Re: Harold D. Thompson Regional Water Reclamation Facility (HDTRWRF)
Lower Fountain Metropolitan Sewage Disposal District (LFMSDD)

Submittal No.:	05500-018
Date of Submittal:	August 29, 2012
Title:	Operations Building Shop Drawings for Stair Columns and I-Beams
Specification Section:	05500
Manufacturer:	CSM Industrial Constructors

The referenced submittal has been stamped "**Make Corrections Noted**". Our comments are as follows:

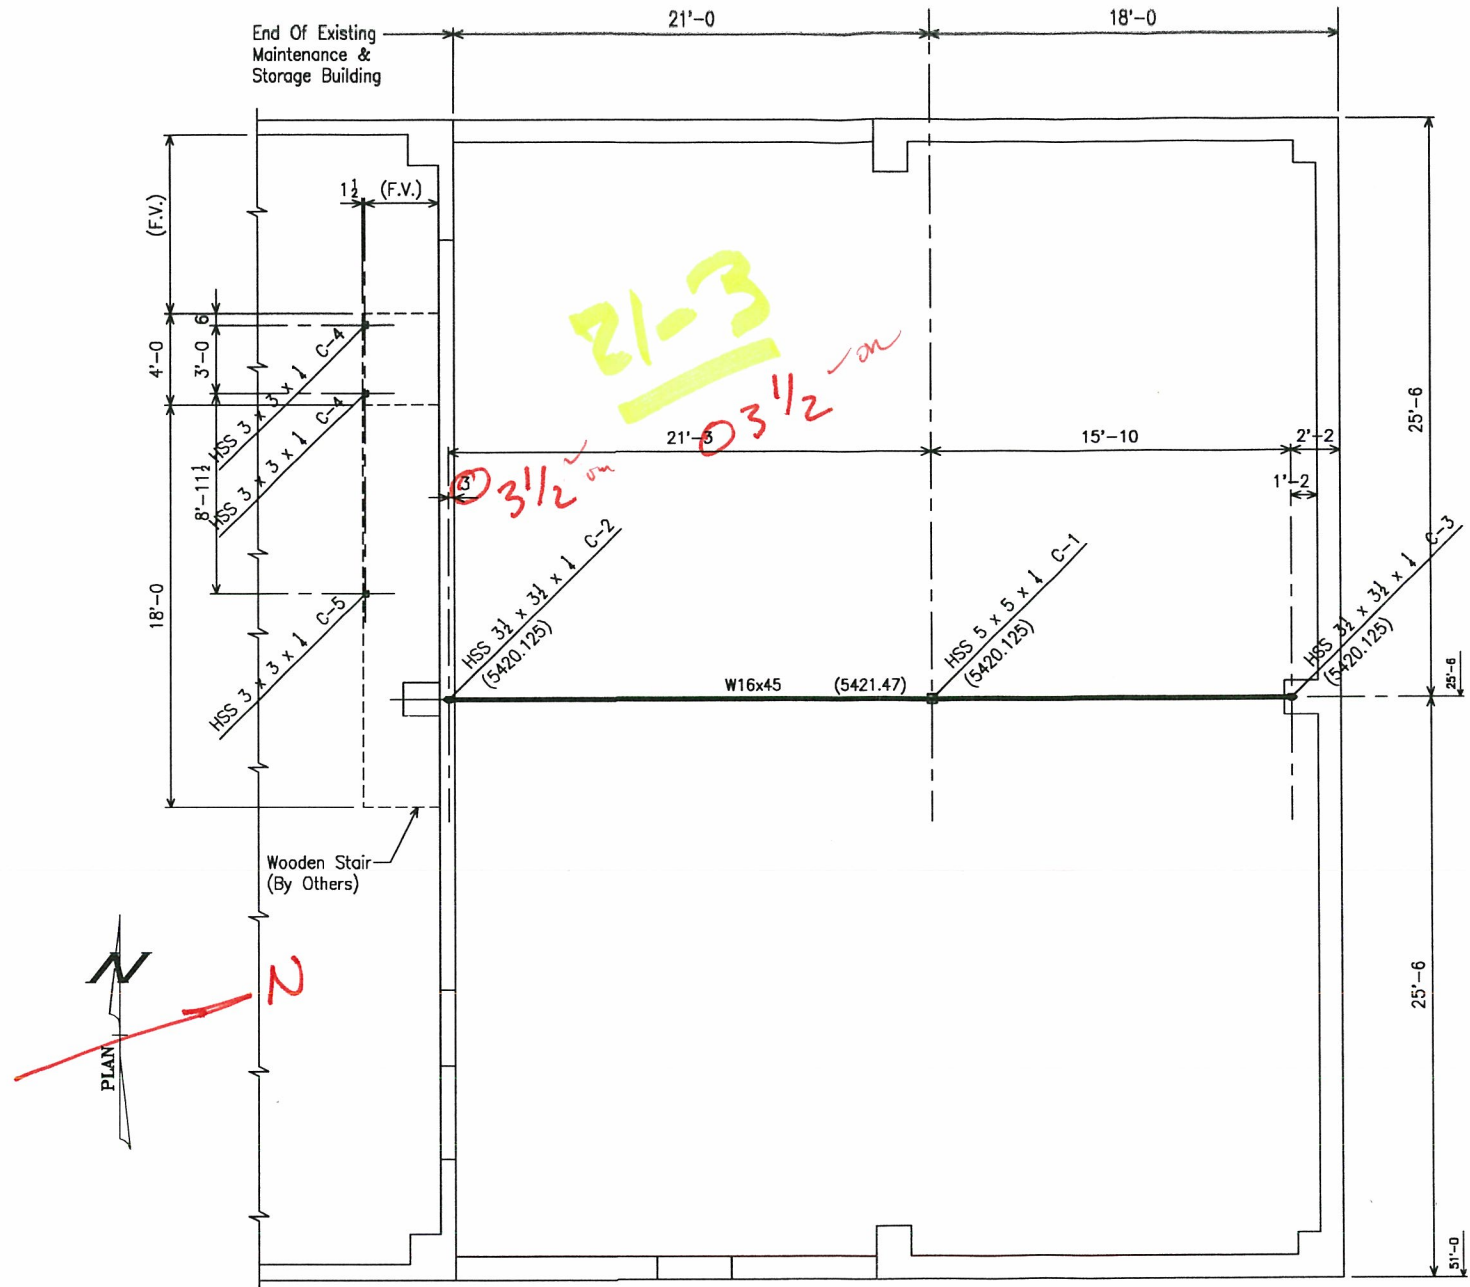
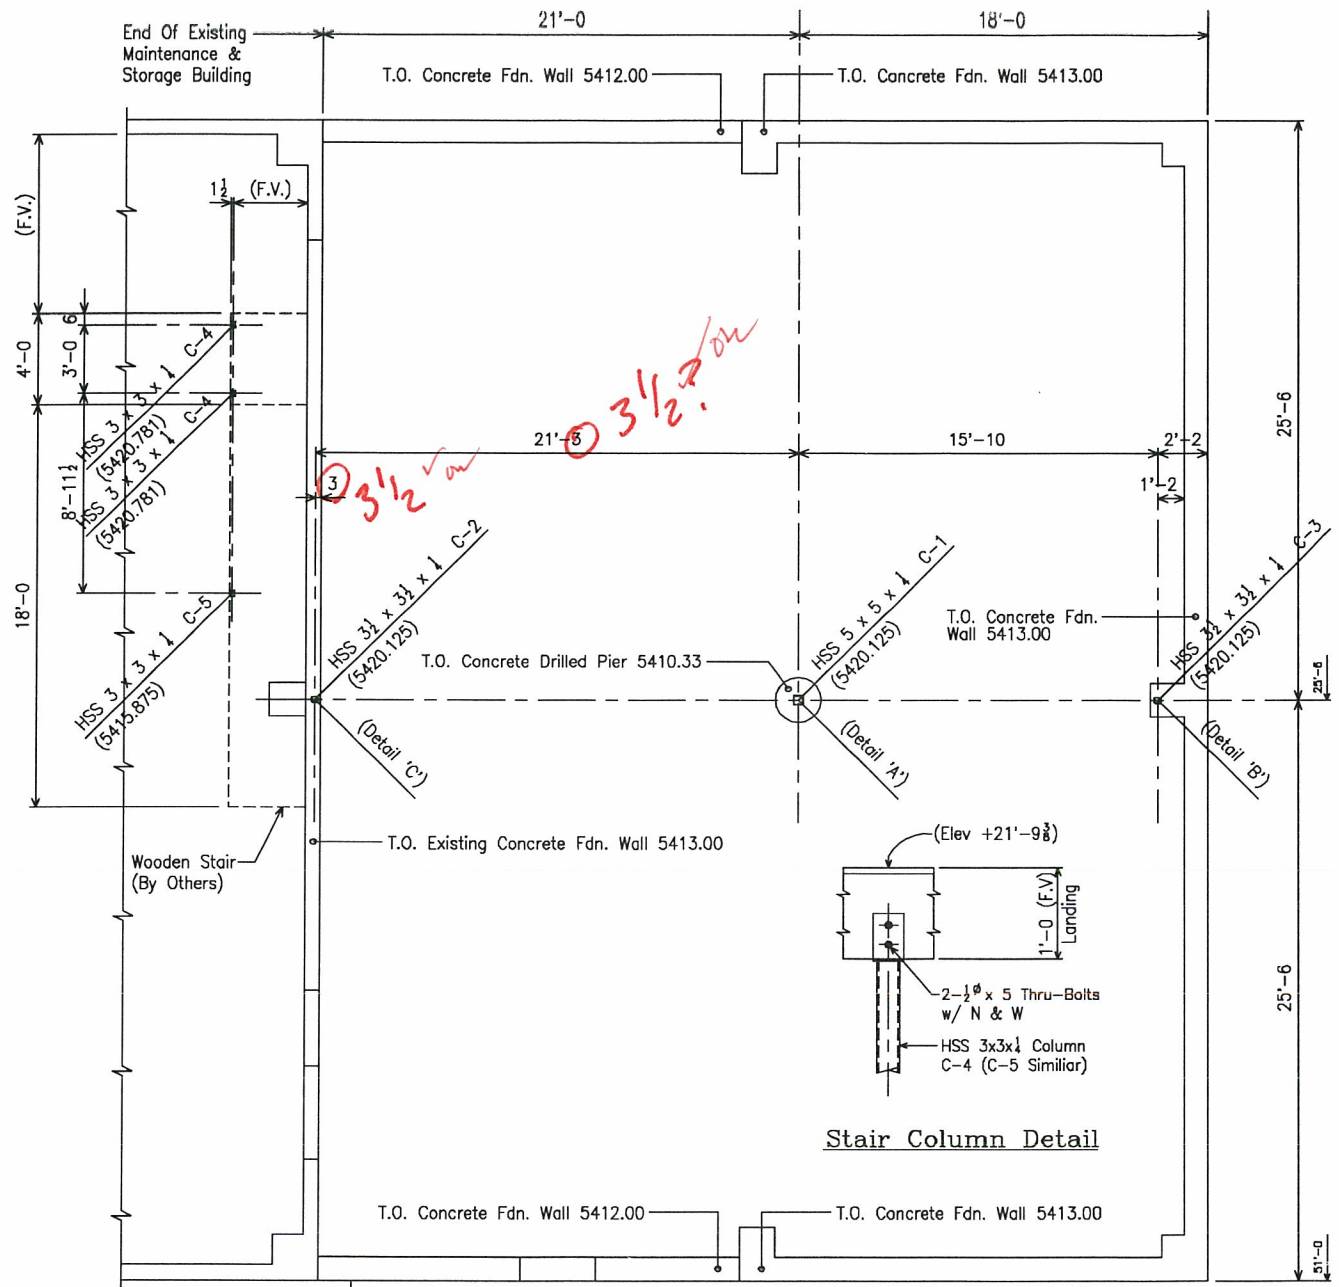
1. The dimension for the southerly span of the interior second level support beam requires revision. Refer to the attached marked plan providing for a centerline to centerline bearing dimension of 21'-3½". GMS, Inc. will issue an ESI revising the "Issued for Construction" plans in this matter. Similarly, the setback to the center of bearing from the face of the existing concrete foundation wall requires revision to be 0'-3½".

2. Revise the drilling of column base plates as marked on the attached drawing, Drawing No. E-1, to reflect two ¾-inch diameter anchors at Detail 'B' and Detail 'C.'

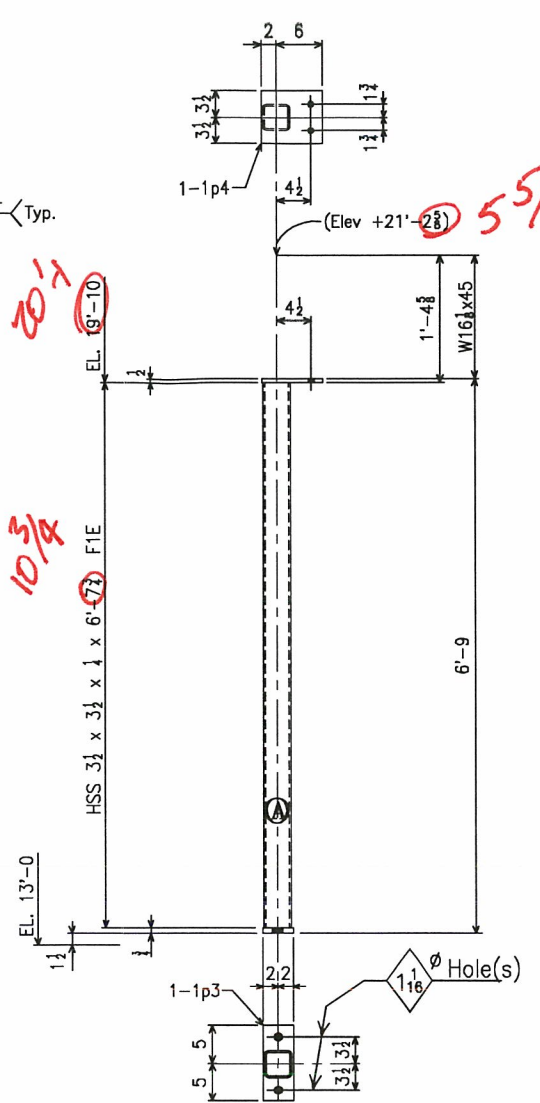
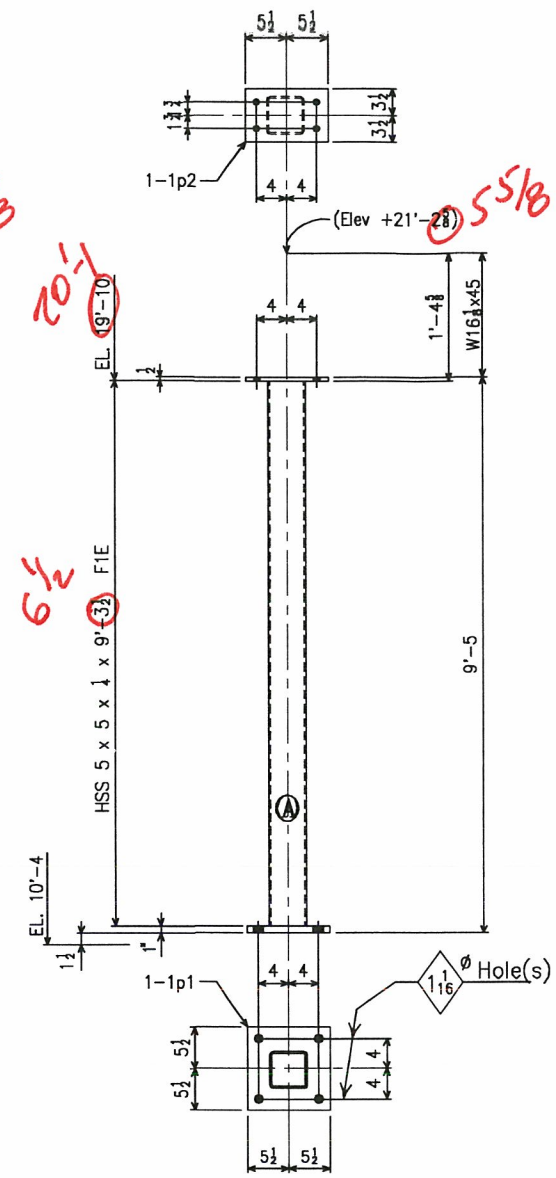
3. Refer to Drawing No. ONE, dated August 17, 2012, which has been marked to reflect modifications to the column length at Columns C-1, C-2 and C-3.
4. Refer to Drawing No. 2, dated August 17, 2012, which has been marked to reflect the change in upper level support beam length in the southerly span. Provide for the handwritten changes made.
